SERVICE BULLETIN

ENGINE - HP TURBINE ROTOR AND STATOR ASSEMBLY - REPLACE THE STAGE 1 AND 2 HP TURBINE WIRE SEAL - CATEGORY CODE 6 - MOD.ENG-72-0022

V2500-ENG-72-0022

Location of Stage 1 and 2 HPT Seal
Fig.1

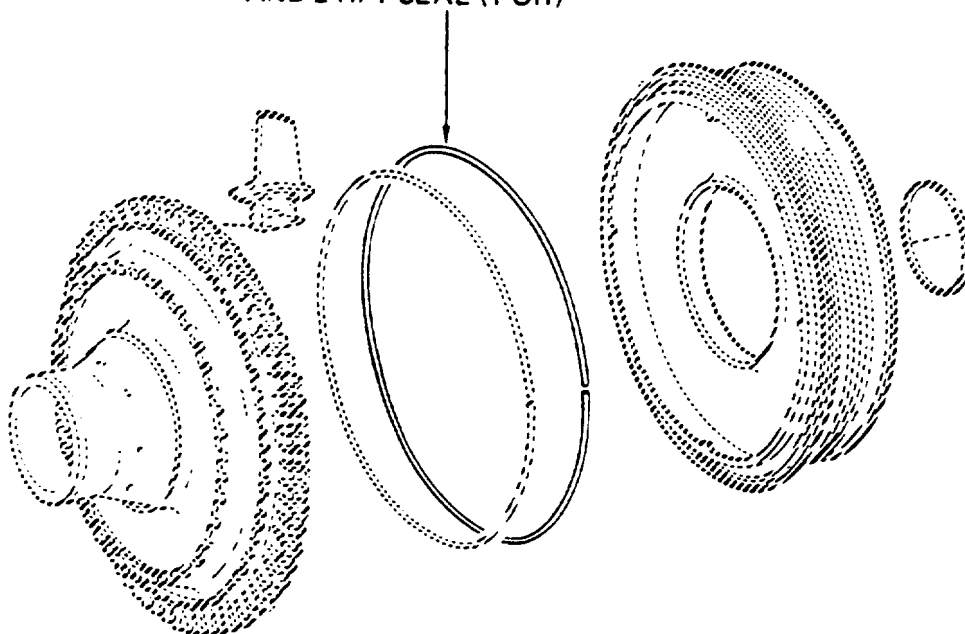
- (1) The durability of the HPT Stage 1 to 2 Seal is improved by a change from a nickel seal to a nickel alloy seal.

REMOVE THE PN 2A0044 STAGE 1
AND 2 HPT SEAL (1 Off) AND
INSTALL THE PN 2A0140 STAGE 1
AND 2 HPT SEAL (1 Off)

- (1) Install the PN 2A0140 Stage 1 and 2 HPT Air Seal (1 off) by the approved procedure in Reference (1), Chapter/Section 72-45-00, Assembly, Figures 1 and 2 as follows:
 - (a) Make sure that the PN 2A0140 stage 1 and 2 HPT Air Seal (Part B) is trimmed to the gap shown in Figure 2.
